ADDENDUM NO. 1
Amelia River Waterfront Stabilization Parking Lots C & D
City of Fernandina Beach
Invitation to Bid # 21-06
Issued: May 25, 2021

III. Changes to Drawings: (See attached)

**BID SET
 ADD. #1**

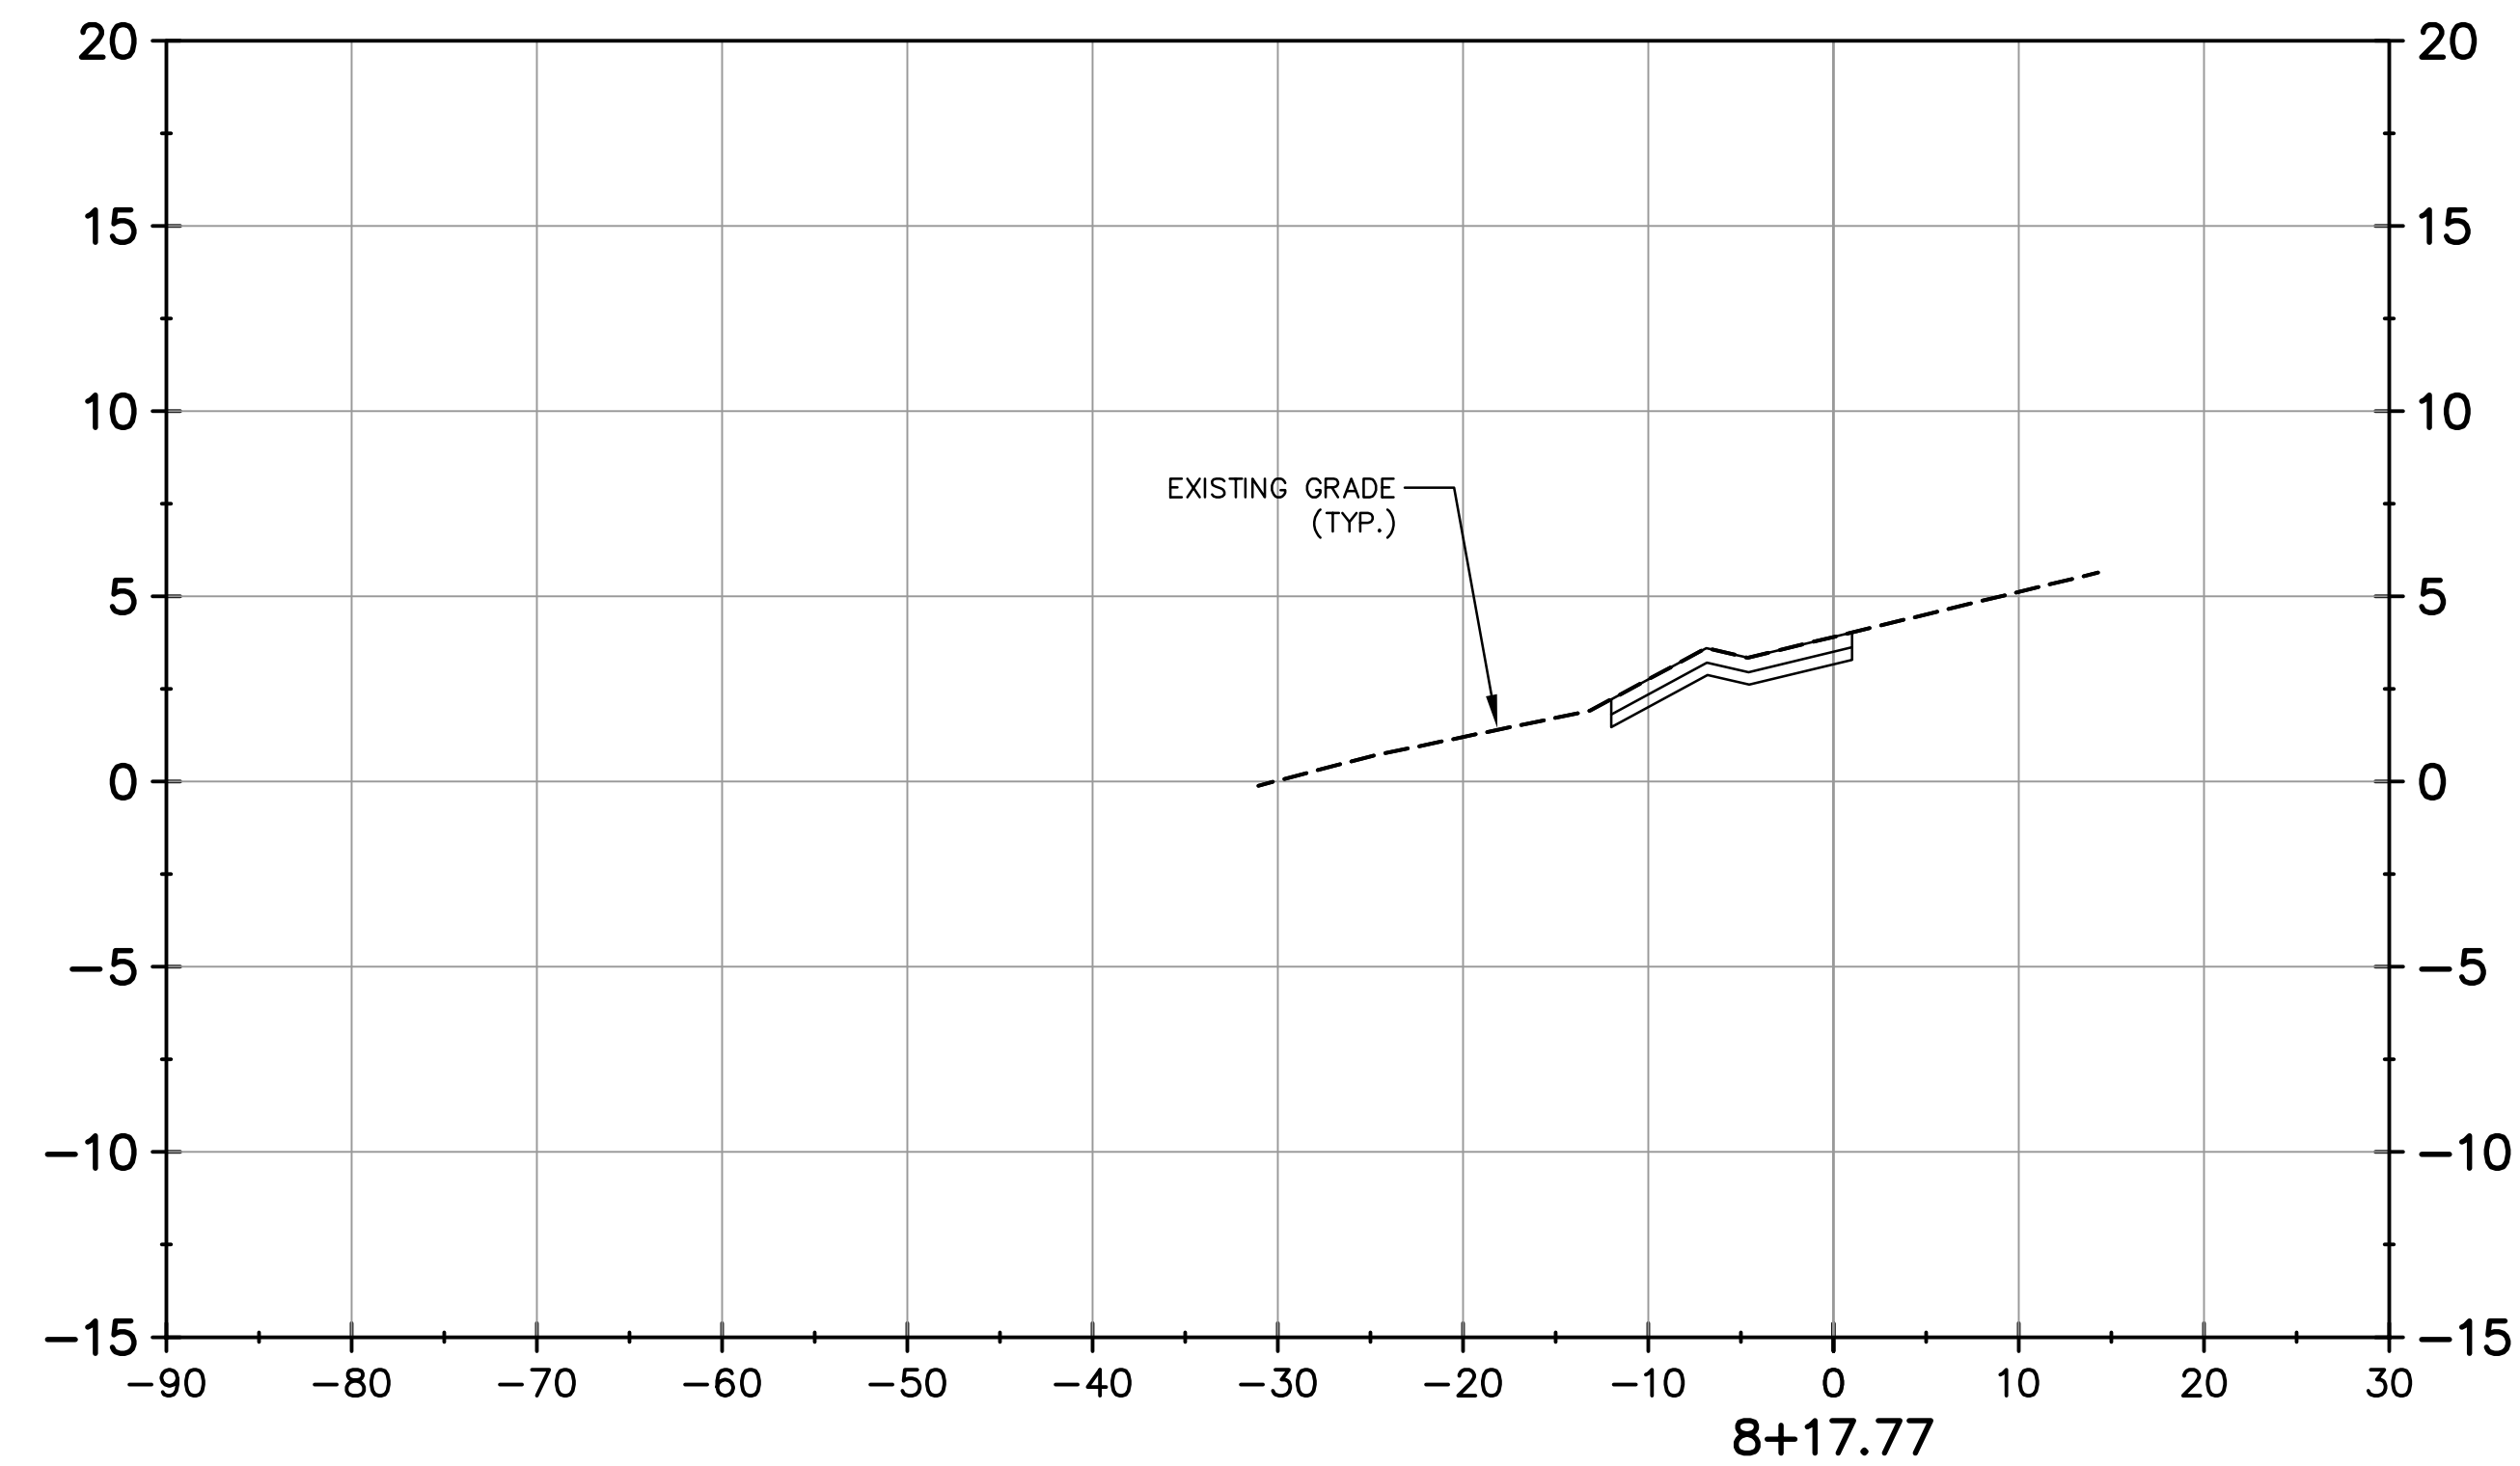
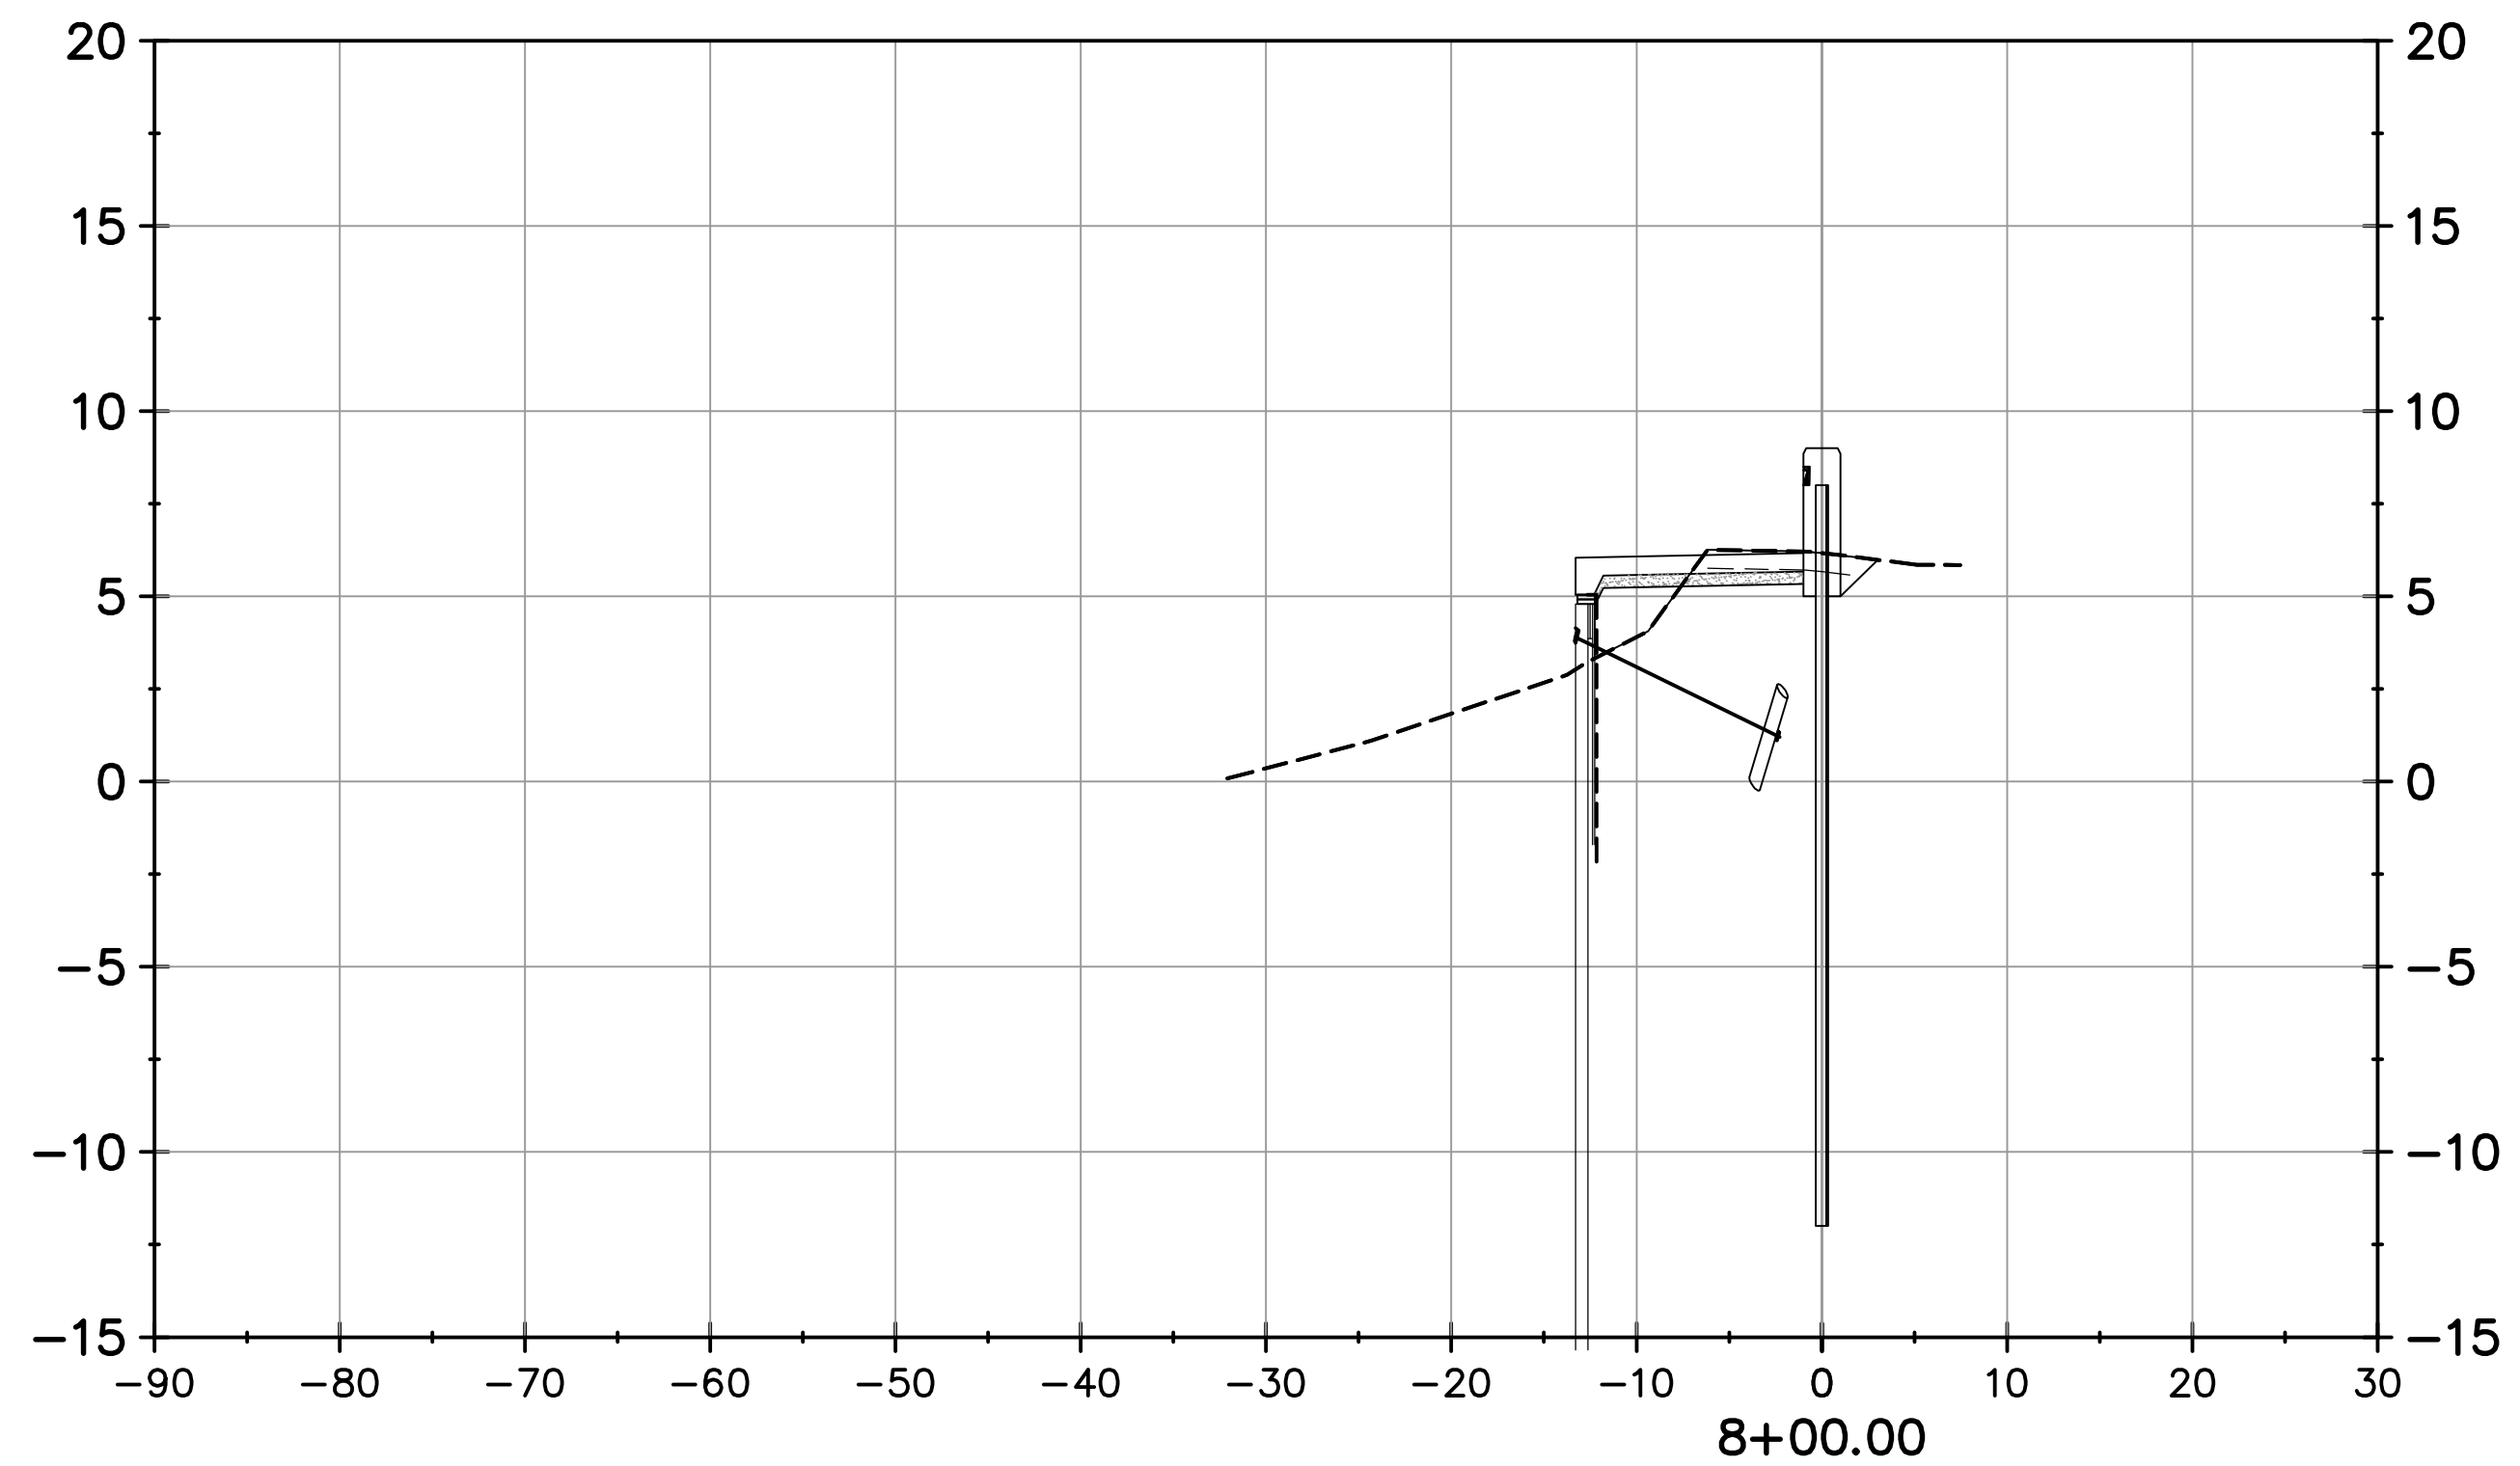
- 24) Sheet C6-5 - Revised I-Wall & Boardwalk Alignment and Cross Sections Adjusted.
- 25) Sheet C6-6 - Revised I-Wall & Boardwalk Alignment and Cross Sections Adjusted.

ALIGNMENT MOVED; CROSS SECTIONS ADJUSTED
